**Manitoba Clean Environment Commission
Hearing for the Vivian Silica Sand Extraction Project (Project)**

Sio Silica Corporation (SSC) Responses to Information Requests (IRs) Round No. 1

Figure 2. Bru 95-2 CWS permitted injection well south of Vivian 2019. Illustration is by D. M. LeNeveu. Well information report was from Manitoba Groundwater.

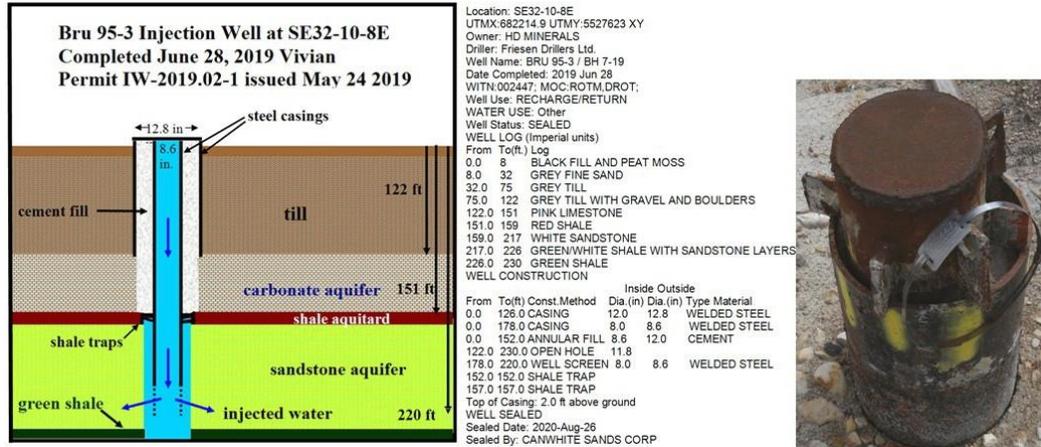
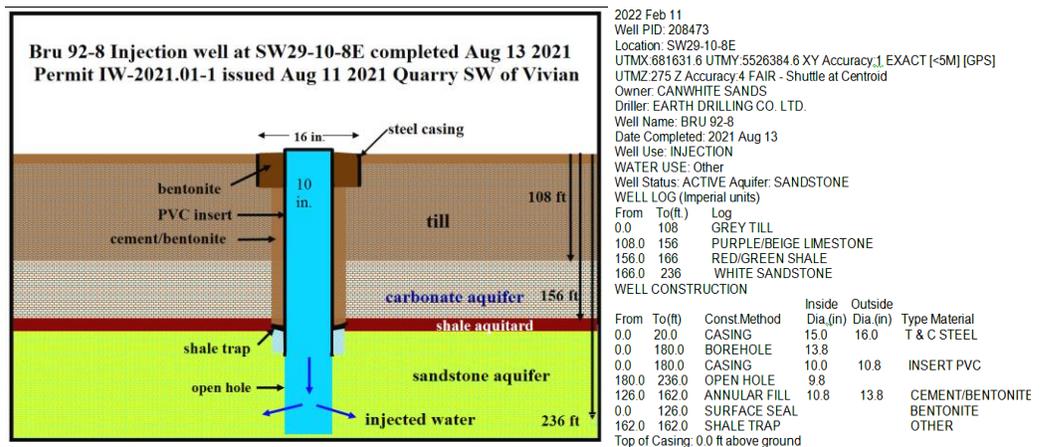
The wells Bru-95-2 and Bru 95-3 do not conform to the Sio Silica design for extraction wells given in supplementary filing of June 2, 2022, Silica Extraction Method and illustrated in figure 5. Only a single casing in Bru 95-2 and Bru 95-3 extends into the sandstone. A single casing extending into the sandstone could not have been used for simultaneous water re-injection and sand extraction. An outer casing was installed into the carbonate with the annular spacing sealed. The sealing date of the annular spacing cannot be determined. Manitoba Groundwater issues one combined well information report for extraction and sealing even though for the sealing dates reported that are much later than the completion date, two reports are required. At the time of sand extraction the annulus between the inner and outer casing could have been open. In this event, according to the well design, water could have been re-injected into the carbonate formation only which is not allowed by regulations. Thus valid full-scale field tests with re-injection that conforms to the Sio Silica EAP sand extraction well design could not be performed on these two wells. This leaves only well Bru 92-8 available for full-scale filed tests with water re-injection. The design of well Bru 92-8 is illustrated in Figure 4.

Therefore it appears not only was no production liner used, Bru 92-8 was eventually used solely for water re- injection. Use of an extraction well solely for re-injection does not conform to the Sio Silica extraction design and protocol. Without a production tube extending into the sandstone, process wastewater could not have been re-injected into the aquifer by gravity as per the Sio Silica well cluster extraction protocols and as shown in figure 5.

Figure 3. Acrylamide accumulation in Sio Silica Slurry loop. *The illustration was produced by D.M. LeNeveu from model results documented in the DLN WTFM motion brief.*

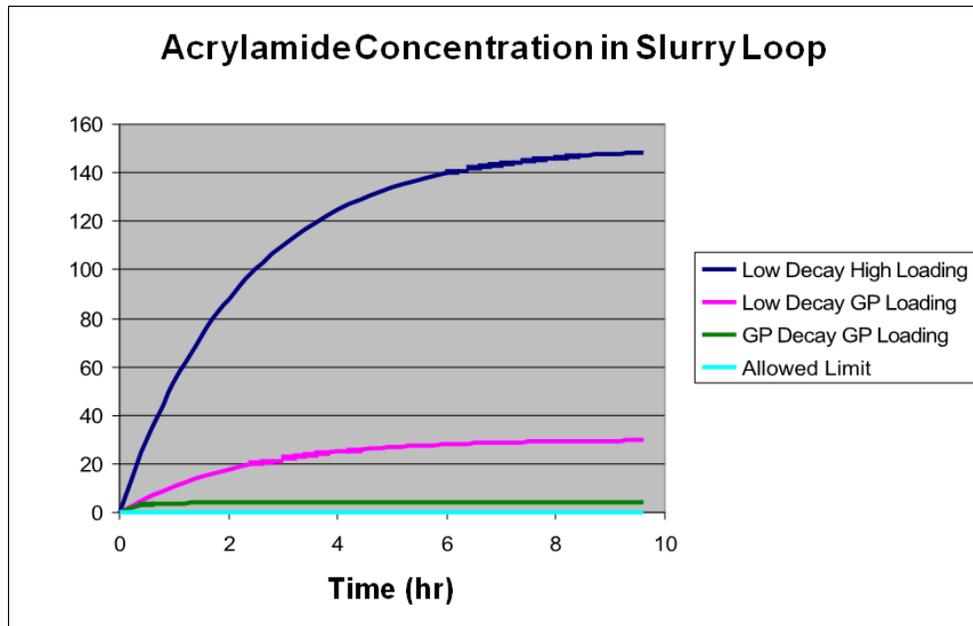
The EAP does not consider slurry line contamination from heavy metals, acid selenium, and acrylamide and the effects of spills or slurry line malfunctions on the environment. Selenium does not require acid for release only oxidizing conditions that would occur in the sandstone aquifer from the re-injected water and air injection operations. The selenium release from all formations was demonstrated in the geochemical shake flask tests of the Hydrogeological Report.

- k) Model the concentration of acrylamide and selenium accumulation in the slurry line as per the methods described in the Great Plains Silica Sand Processing Plant memorandum³ and the brief supporting the DLN and WTFMB motions or by any other appropriate methods. By these methods or other methods considering the amount of CO₂ and SO₂ released to the slurry line from the dissolution of sulphide in the sand, and in concretions, oolite and shale fragments in the slurry line, model the acid concentration, pH, and heavy metal accumulation in the slurry line.

- k) Sio disagrees with the factual statements in the request and the premise of the question. There will not be accumulations of acrylamide and selenium in the slurry line. As a result, Sio declines to respond.

Figure 1. Vivian sand purity from Noble Investment Convention Florida 2019

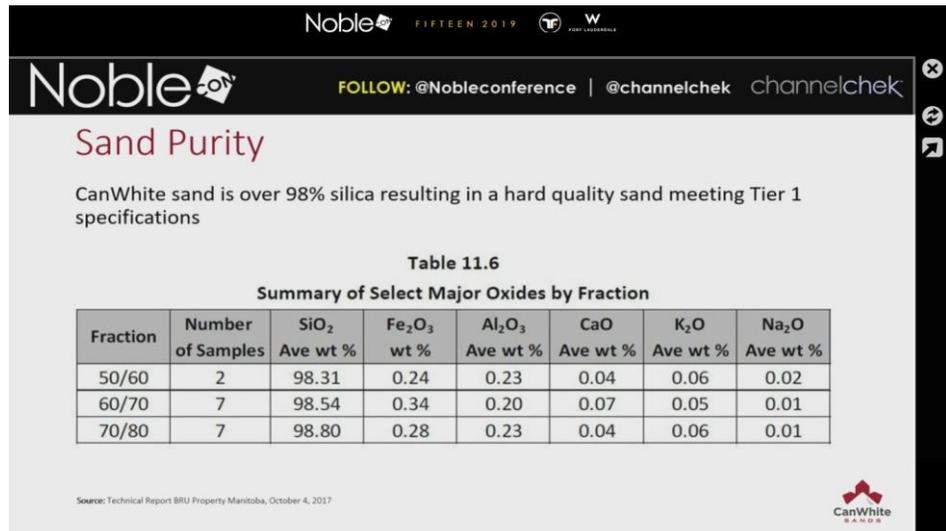
The purity values for the Vivian sand given at the Noble conference are lower than the Sio Silica stated value of 99.85% for high purity use.

- g) Explain why the test results given at the Noble conference are of lower purity than the stated average purity of 99.85% in the EAP.
 - h) Since the only available evidence shown in figure 1, establishes that the Vivian sand is below international standards for high purity sand, explain why and how the Vivian sand can be used for high purity applications.

Figure 2. Stantec data for maximum long term allowable silica sand extraction cavity span compared to calculated values from equation 1.

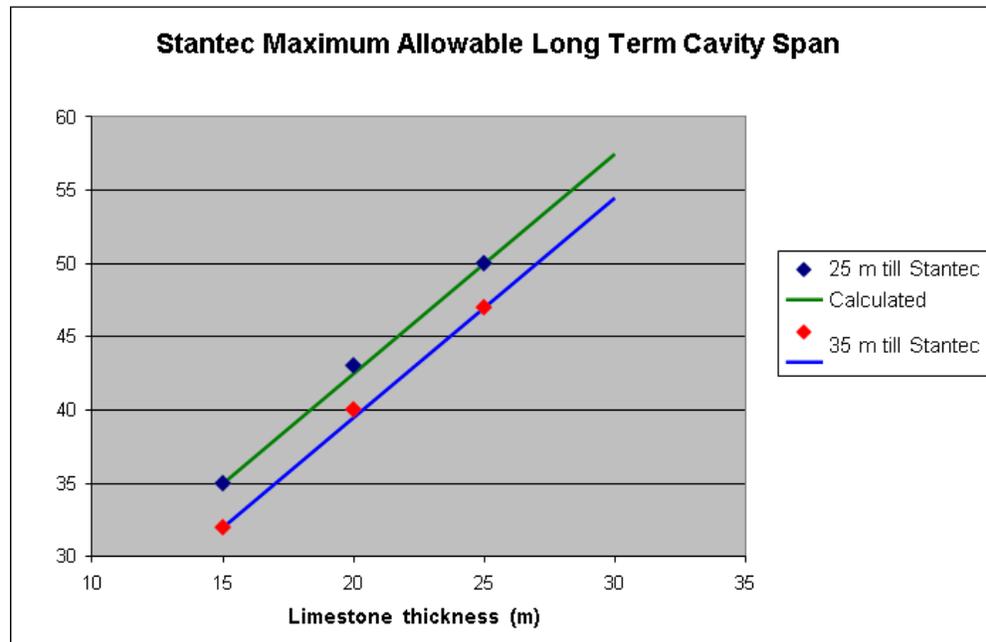
Figure 2 establishes that equation 1 provides accurate values for maximum allowable long term silica sand extraction cavity span for any limestone and glacial till thicknesses within the range of data over the 24-year Sio Silica Project area.

The conclusion that the design cavity span is too large is obvious from the Stantec data illustrated in figure 2 and the range of till and limestone thicknesses reported for 44 Sio Silica wells in the 24-year project area. Figure 3 confirms that the design cavity span is invalid.

Figure 3. Limestone and till thickness and maximum allowable long-term excavation cavity span over the Sio Silica 24 year project area

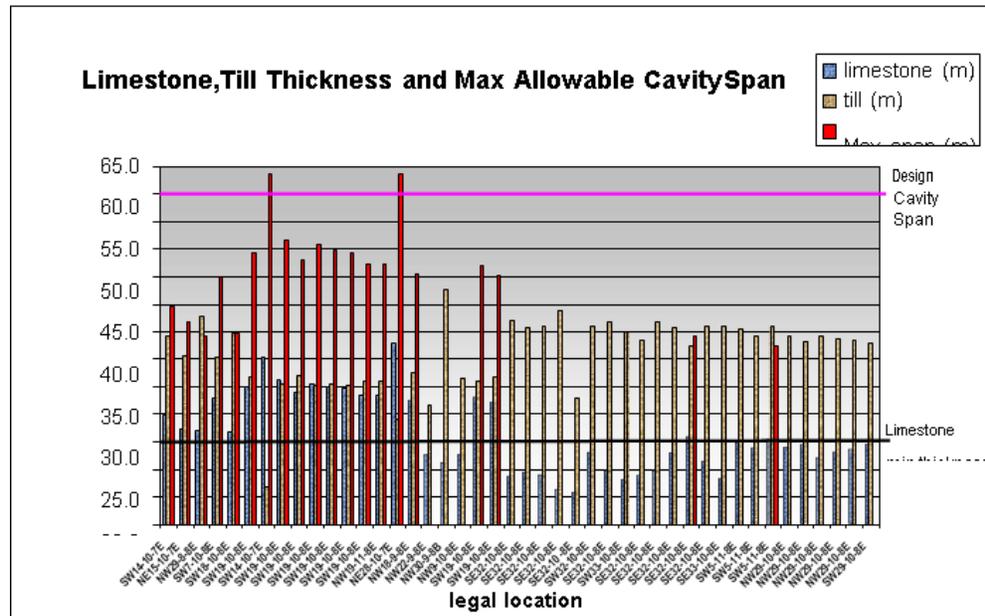
For the documented limestone and till thicknesses a long term cavity span of 60 meters given in Document #1 is too large for stability for almost all the wells in the 24-year Project Area. The design cavity span of 60 meters must be reduced considerably for the extraction design to be viable. The maximum allowable extraction cavity span must be determined anew for each extraction cluster location based on the local limestone and till thicknesses.

- b) Revise the well cluster design according to the information illustrated in figure 3 on the maximum allowable cavity span based on the data from the 44 Manitoba Groundwater Well Information Reports. According to the analysis from the DLN WFWMB motion brief, the cavity span must be much smaller than the current design specification of 60 meters, of the order of 40 meters or less depending on the local geological and geo-mechanical properties of the extraction location. The long term allowable cluster span for each extraction location must be determined by a new fully three-dimensional geo-mechanical modeling that includes analysis of the sand pillar stability. Local geo-mechanical properties must be measured at each extraction location to perform this analysis.

Figure 1 a and b. Extraction wells Bru 92-2 (a) and Bru 92-3 (b) completed at a quarry south west of Vivian. Illustrations by D.M. LeNeveu was based on the well information report received from Manitoba Groundwater shown on right. Photographs were reproduced with permission of photographer

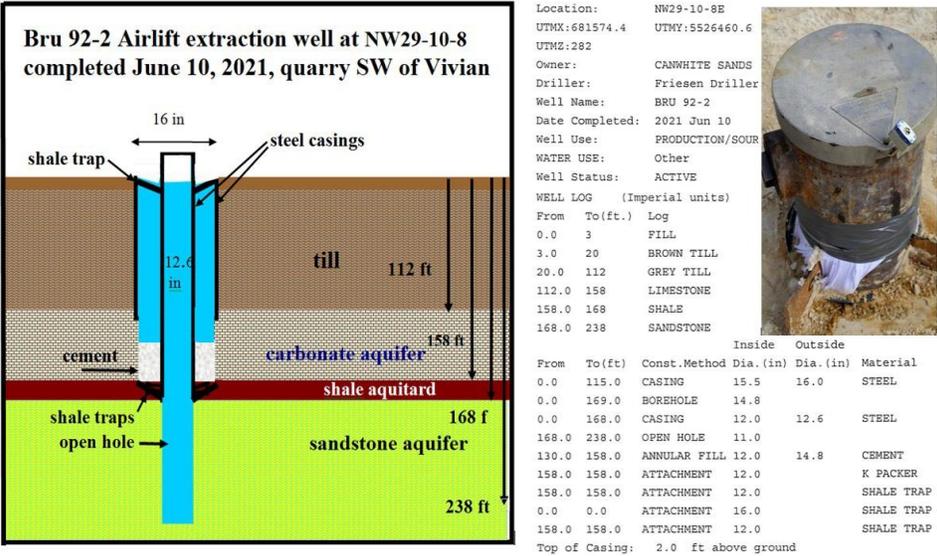
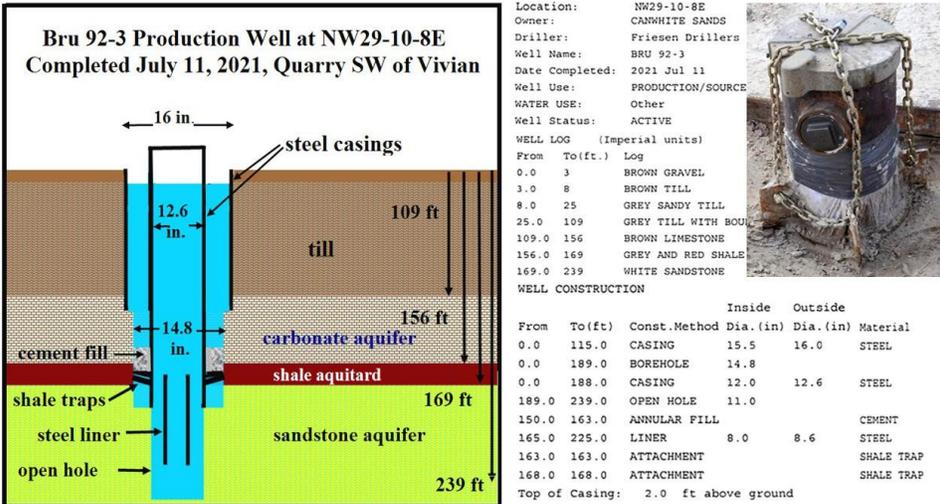
These extraction wells do not conform to the well design given in Sio Silica Supplemental Information Document #1 – Silica Extraction Method June 2, 2022 or the earlier design given in figure 2-2 of the extraction EAP. The well design of Bru 92-8 given in IR 002 DLN is reproduced below.

This remark explains why the central steel liner appears to be unsupported in the illustration in figure 1b.

There is no return route for re-injected water to the sandstone through the outer annulus in Bru 92-2 or Bru 92-3 however there is a return route into the carbonate aquifer. The steel liner of Bru 92-3 extends 56 feet into the sandstone while the open hole extends 70 feet into the sandstone. The steel liner does not extend to the surface therefore cannot be a production tube as illustrated in figure 1b. The remark, *“stuck in the sandstone,”* in the well information report demonstrates that a removable steel liner was likely lowered into the hole during airlifting to prevent sand from collapsing. As described in the CWS patent, the air injection tube would extend below the liner injecting directly into the sandstone to loosen and mobilize the sand. The air injection would be pulsed as described in the patent. Since the inner liner does not penetrate

- s) What is the purpose of the duct tape and cloth skirt on the outer casing of wells Bru 92-2 and Bru 92-3 as shown in figure 1?
- t) Is the open outer annulus with no permanent seal to be used during production even for a limited time during extraction and permanently sealed later?

a) Sio has tested several different well designs and Bru 92-2 and Bru 92-3 are virtually the same as what is proposed in the supplementary filing – Silica Extraction Method. Figure 2-2 in the filing shows virtually the same design as what was constructed for Bru 92-2 and 92-3. It is not clear what the author understands to be different from the proposed design other than steel casing was used in the Bru 92-2 and Bru 92-3 wells due to availability at the time, whereas PVC casing is proposed. Both steel casing and PVC casing are regularly used in water wells every day all around the world.

Figure 3 . Sio Silica extraction well design. *Illustration was reproduced from Sio Silica Supplement Information – Document #1 – Silica Extraction Method Vivian Sand Extraction Project (File # 6119.0)*

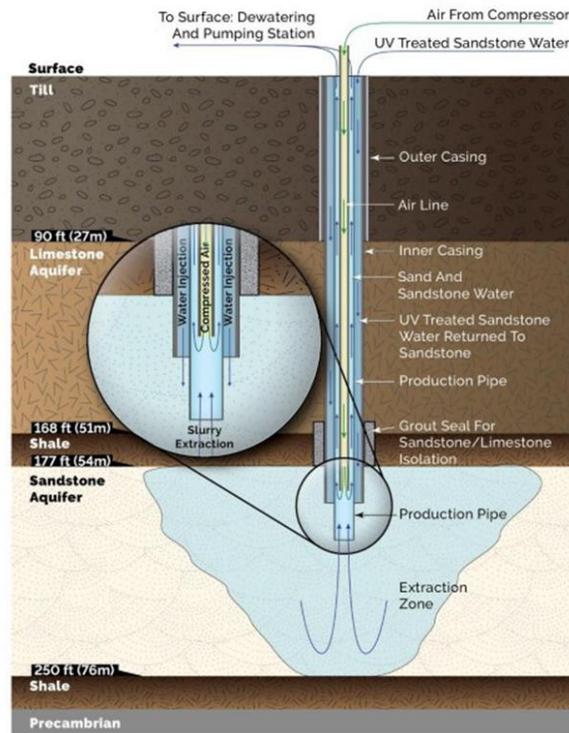
- c) If the extraction design given in figure 3 of the Supplementary filing of June 2, 2022 is to be used during production please give detailed information on where and when this production well design of figure 3 has been implemented and tested. Give the name of implemented extraction wells, the drillers reports for the wells, the Manitoba groundwater well information reports, and all the test data for the wells including sand and water extraction amounts, rates, time, duration, water re-injection amount, rate, time and duration, pressure measurements in the formation and all other collected data.
